Access Compliance Report

Public Rights-of-Way

Intersection ID: 24499	Main Street: BECKMORE_PL	Cross Street: SAINTFIELD_PL	Location: NW
ADA ID: 877D3A57B037	Ramp Type: Perp	Initial Pass/Fail: Fail	Overall Compliance: No
			Severity Score: 13.75

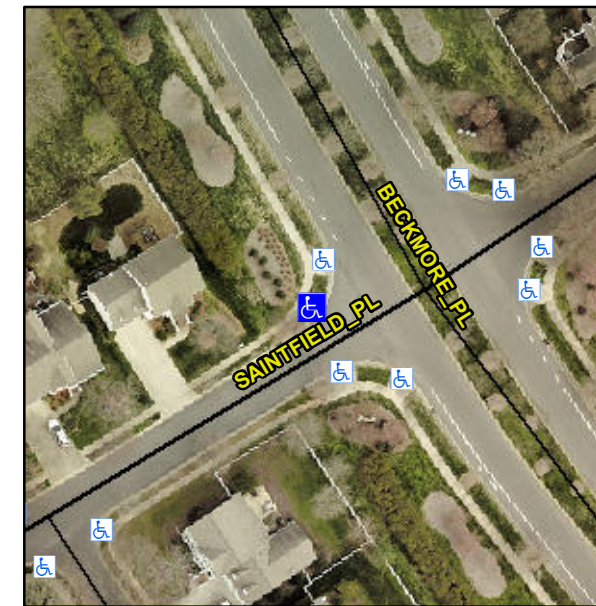
Not Found, R304.2.2, R304.5.3

Compliance	Description	Data	Compliance	Description	Data
N/A	Ramp Length (in)	78.0	No	Ramp Slope (%)	8.6
Yes	Ramp Width (in)	48.0	No	Ramp XSlope (%)	3.3
N/A	Flare Type LT	N/A	N/A	Flare Type RT	N/A
N/A	Flare Slope LT (%)	N/A	N/A	Flare Slope RT (%)	N/A
N/A	Flare Traversable LT?	N/A	N/A	Flare Traversable RT?	N/A
N/A	Landing Length (in)	N/A	N/A	DWS Provided?	N/A
N/A	Landing Width (in)	N/A	N/A	DWS Contrast?	N/A
N/A	Landing Slope (%)	N/A	N/A	DWS Length (in)	N/A
N/A	Landing X Slope (%)	N/A	N/A	DWS Full Width?	N/A
N/A	Landing Curb? (Y/N)	N/A	N/A	DWS Offset (in)	N/A
N/A	Shared Landing?	N/A			
N/A	Gutter Ponding?	N/A	N/A	Gutter Slope (%)	N/A
N/A	Gutter Lip Ht (in)	N/A	N/A	Gutter X Slope (%)	N/A
N/A	Painted X Walk1?	No	N/A	Painted X Walk2?	N/A
	X Walk 1 Direction	To S		X Walk 2 Direction	N/A
N/A	X Walk 1 Width (in)	N/A	N/A	X Walk 2 Width (in)	N/A
	X Walk 1 Slope (%)	3.2		X Walk 2 Slope (%)	N/A
	X Walk 1 X Slope (%)	4.3		X Walk 2 X Slope (%)	N/A

Remove & Replace Entire Ramp.
